# CITY OF SUFFOLK

## ADDENDUM #1

### Construction of ADA Accessible Boat Ramp, Fishing Platform, Parking Lot, and Shoreline Stabilization for Sleepy Hole Park

Contract No. 15009-CN

2 ENLARGED PLAN  
 A.1 SCALE: 1/8" = 1'

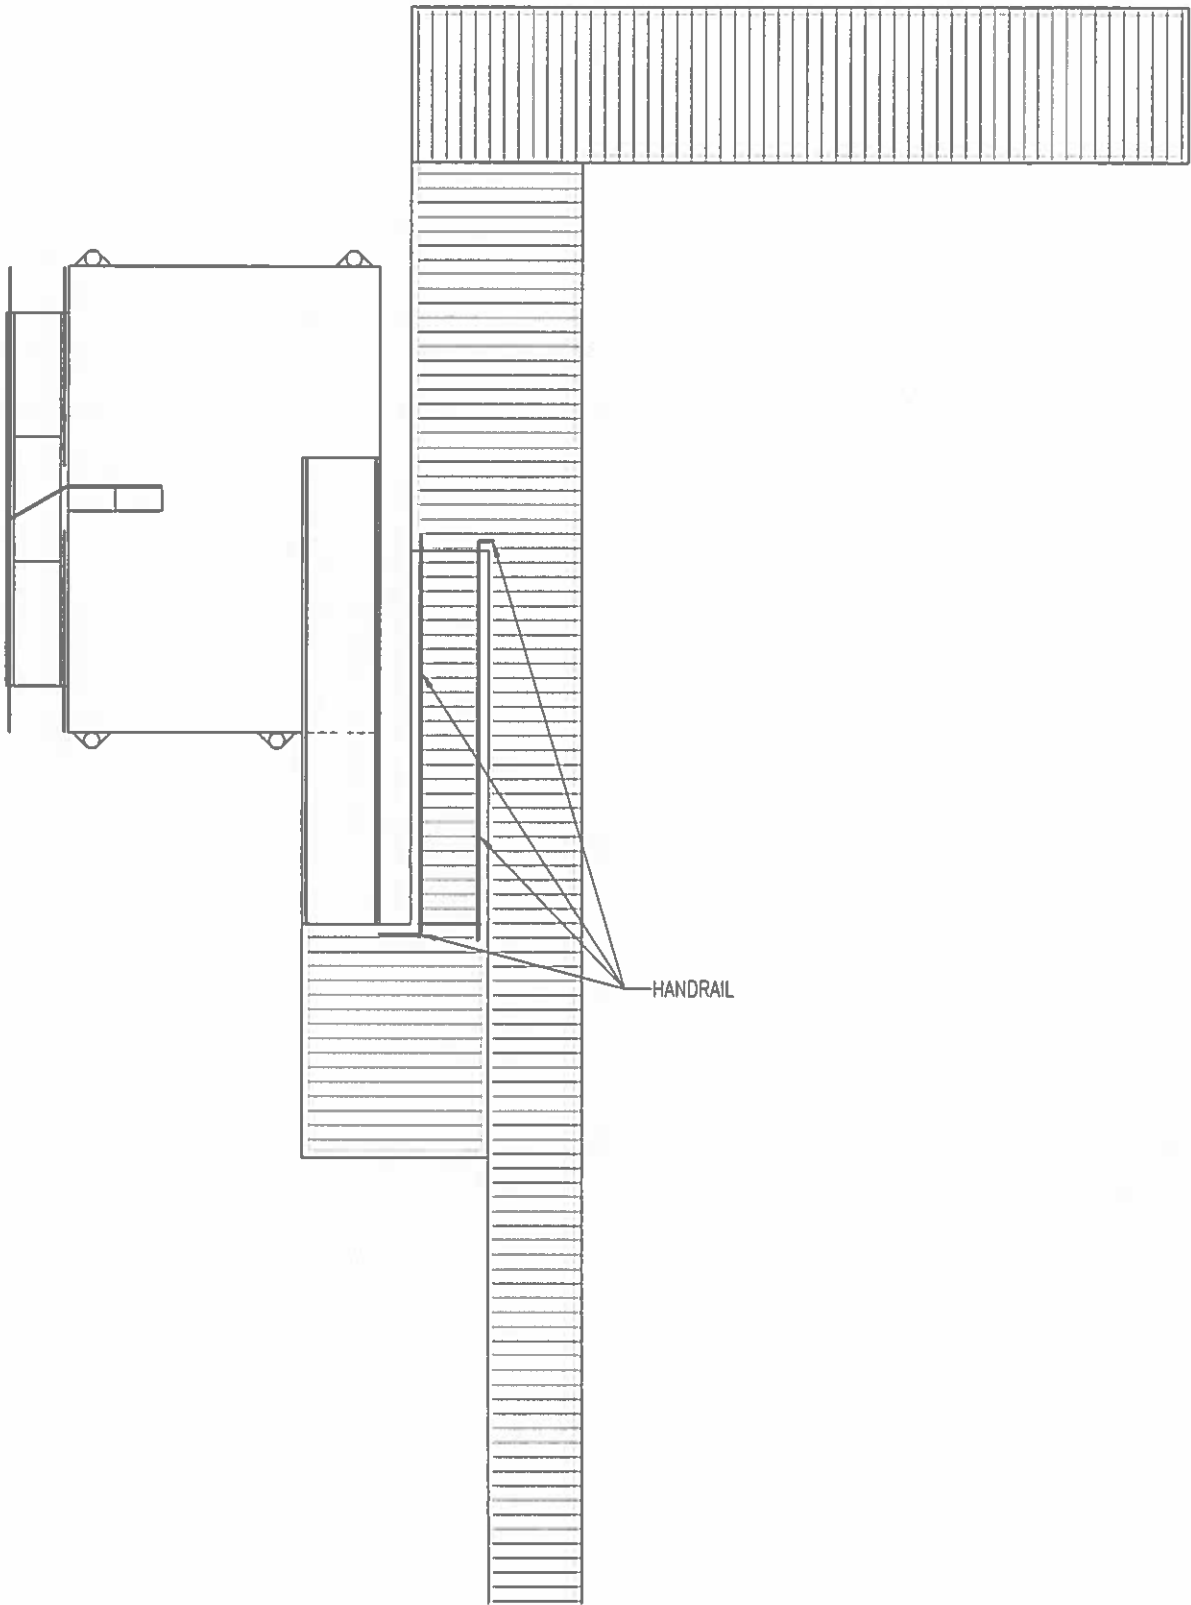
4. **Do the aluminum pickets run along one side of the pier and the aluminum railing the other, around the whole pier?**

*Answer:* The aluminum pickets (Detail 5/A.1) shall be installed on both sides of the first section of pier before the bend (approximately 150 feet). (Option 1 of the Bid Form is for the same section of rail but with wood pickets in lieu of aluminum.) The stationary ramp area (slope > 1:20) shall receive hand rails. (See the attached sketch sheet.)
